DESIGN ADVISORY BOARD Tuesday November 10, 2020 3:00 PM REMOTE MEETING

MEMORANDUM

To: Design Advisory Board
From: Scott Gustin
Re: 160 Bank Street
Date: November 10, 2020

Request: Construct gallery seating area with canopy on south side – seeking alternative compliance as to gallery dimensions

SOUTH ELEVATION

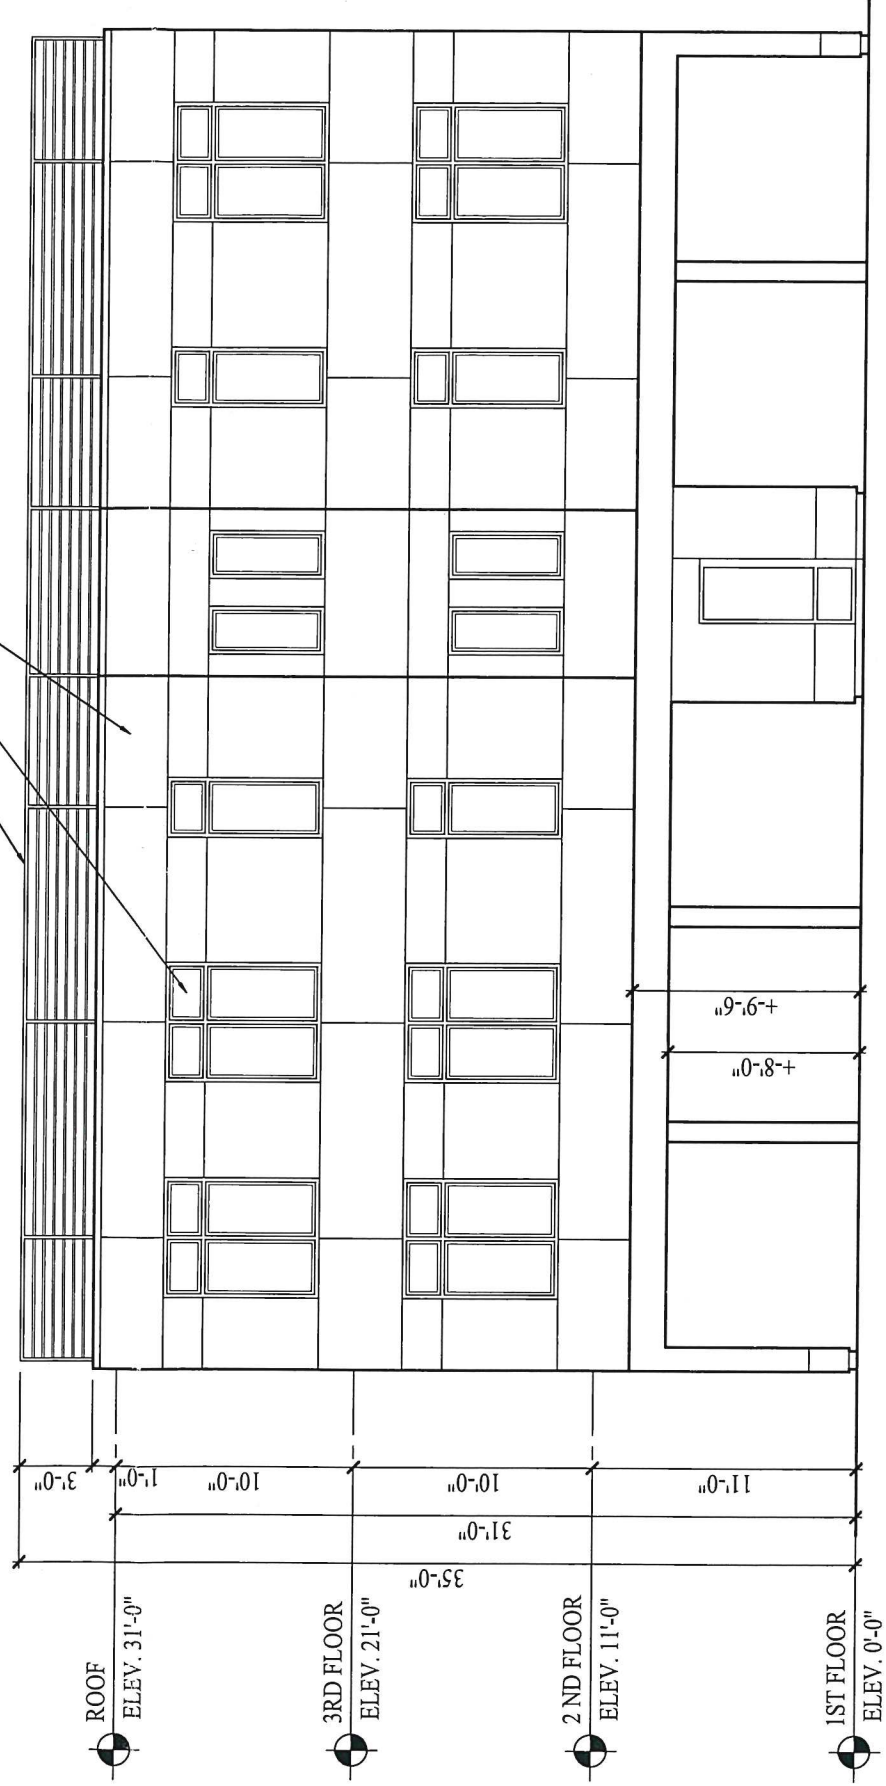
4. Should windows be added to the southwest side of the building, on the upper two stories to break up the monotony of a blank wall facing the neighboring residential property? On both upper floors, this would equate to one additional bedroom window.

2 Pine Street (West) Elevation Existing
 Z5.0
 1/16" = 1'-0"
 0 8' 16' 32'

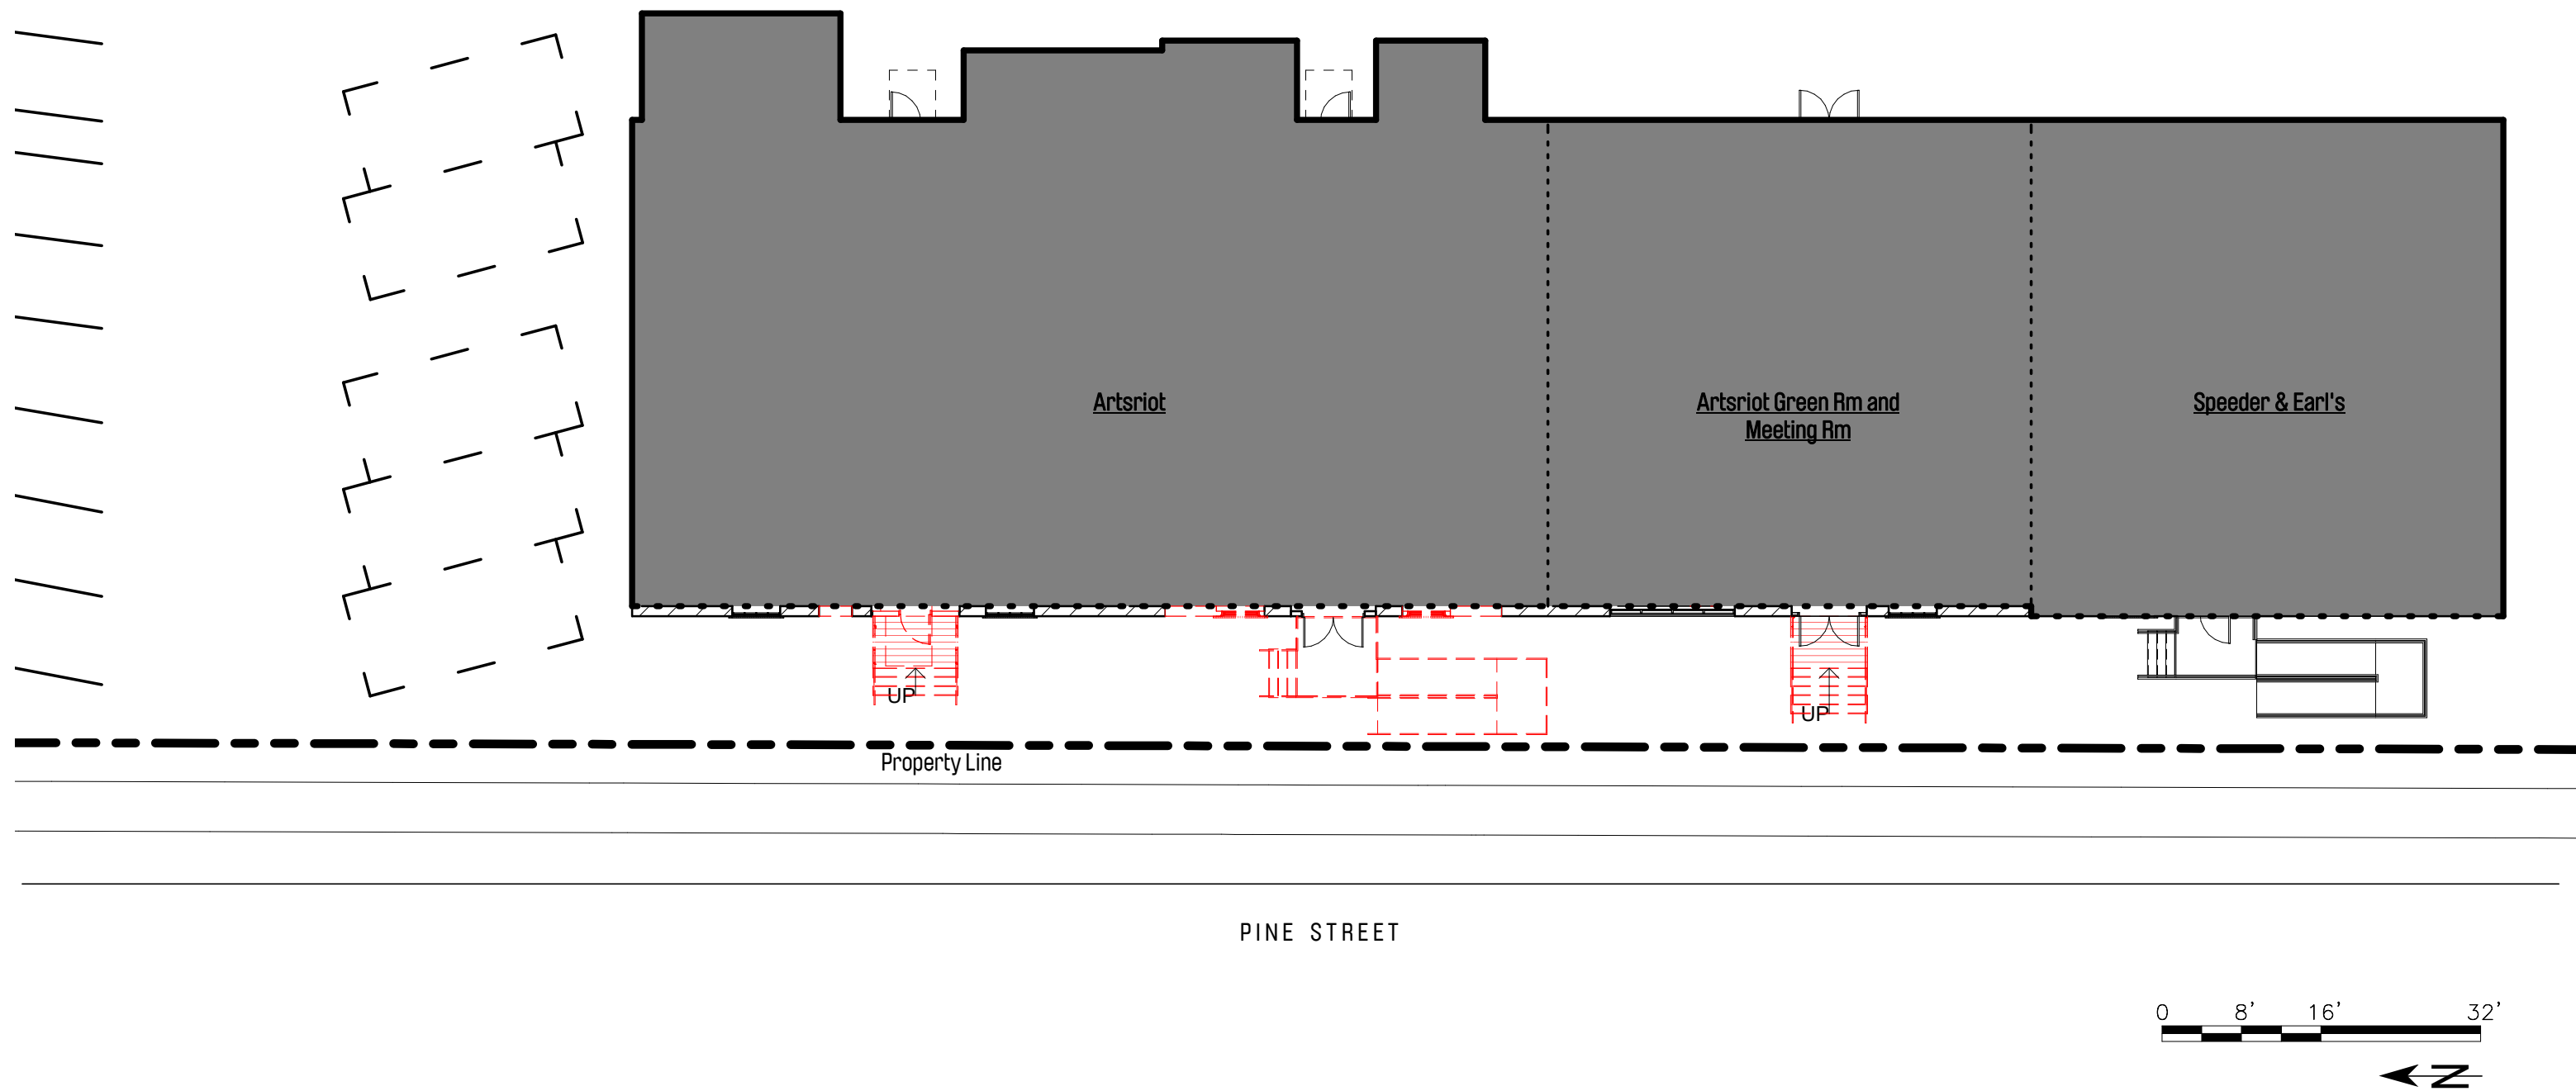
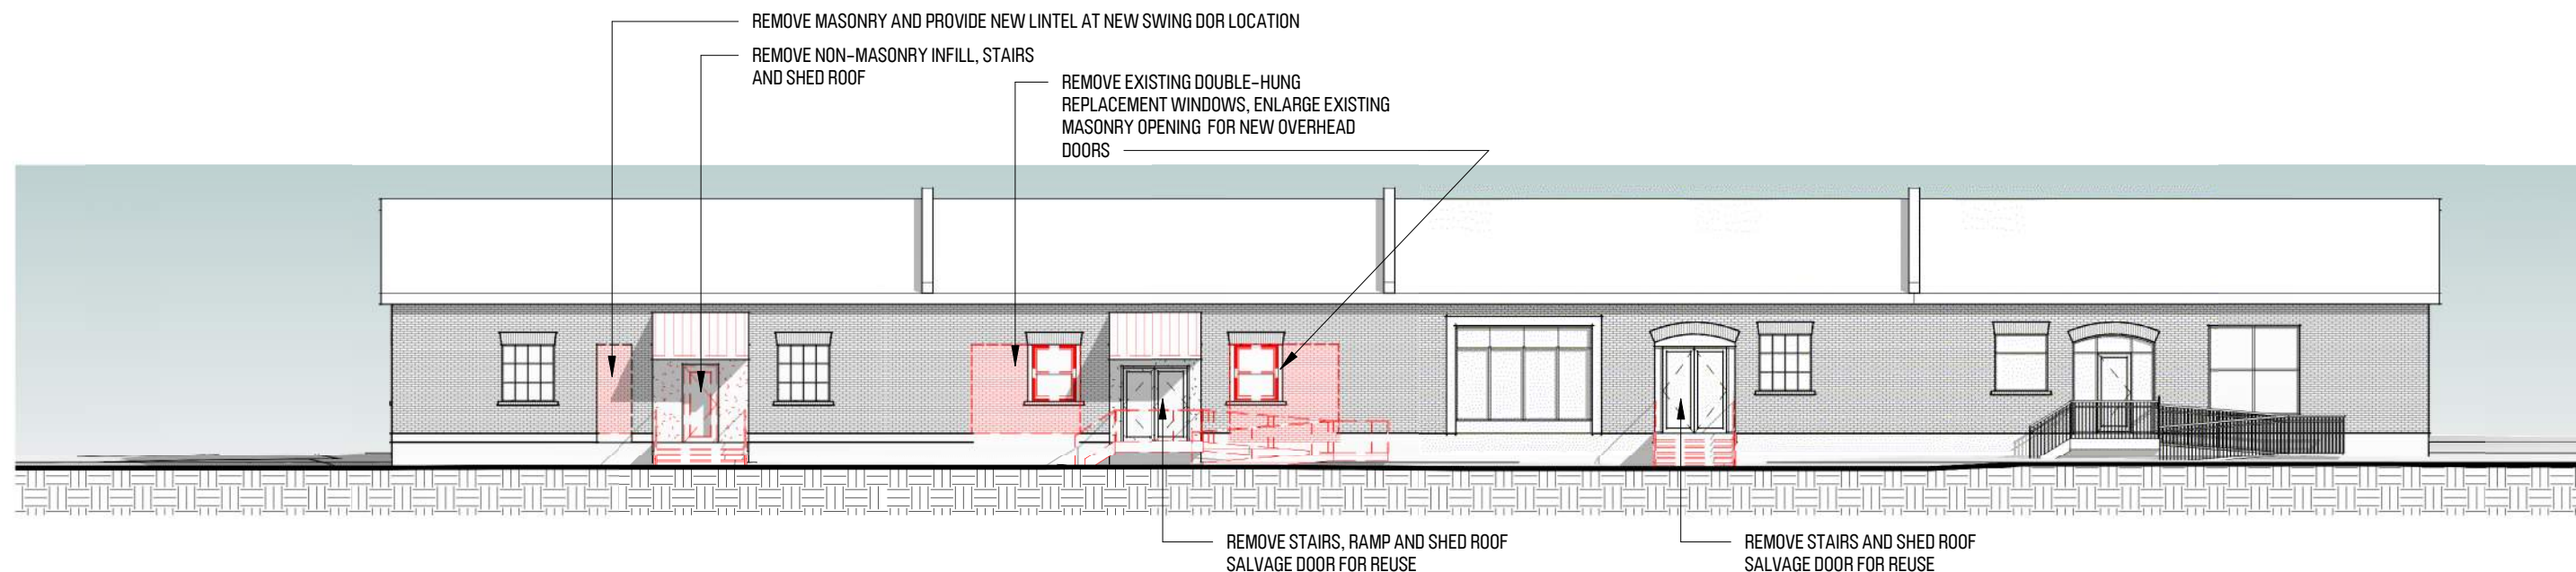
At the north end of the building, a new entry will be created through the masonry façade, and the non-masonry infill entry will be removed and replaced with an overhead door.

At the center of the façade, two double hung window openings will be replaced with overhead doors.

The splayed brick lintels over original openings will be lost, as will the dimensions of original building openings. Although some have previously been altered, others are proposed for alteration that will change those original spatial and design characteristics.

1. The patio wall along the street edge shall be modified to increase the line of site directed at the horizontal along the sidewalk a minimum of 25% of the linear footage.
2. The Board approves the modifications to façade, masonry openings and new fenestration.
3. The Board suggests that any future murals along the street wall be interchangeable.
